Resource Consent Application – Further information request

Application number: LU/0077/23 **Applicant:** Rs Sand Limited

Proposed activity(s): Establish and operate a mineral extraction activity (sand quarry)

NEWCOMBE ROAD SAND QUARRY: NOISE PEER REVIEW

Figure 1: Excerpt of Figure 10 from Hegley report

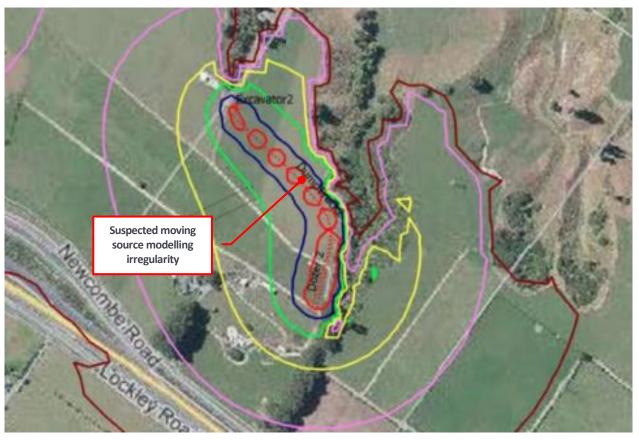
Although included in noise contour outputs (Figures 10 to 12) the body of the report does not discuss any details or provide noise source inputs for the heavy commercial vehicles that will enter and leave the site. We note that the CKL traffic assessment³ estimates average trip generation rates of 78 trucks per weekday (156 truck movements) and eight trucks per hour (16 truck movements). We assume noise modelling is based on the trip generation estimates noted in the CKL report. However, ask Hegley to confirm that this is the case.

With respect to the noise contour calculations displayed in Figures 10 to 12, specifically some of the moving sources, we suspect that the lines used to define the routes of the mobile machinery do not follow the terrain 100% of the time (as indicated in Figure 1 overleaf) this can lead to underprediction of noise levels in some instances when part of the line source dips below the terrain. Can Hegley confirm whether all modelled moving sources follow the terrain. If they do not, we ask that Hegley comment on how this will affect calculated levels at all identified receivers. The re generation of noise contours may be required.
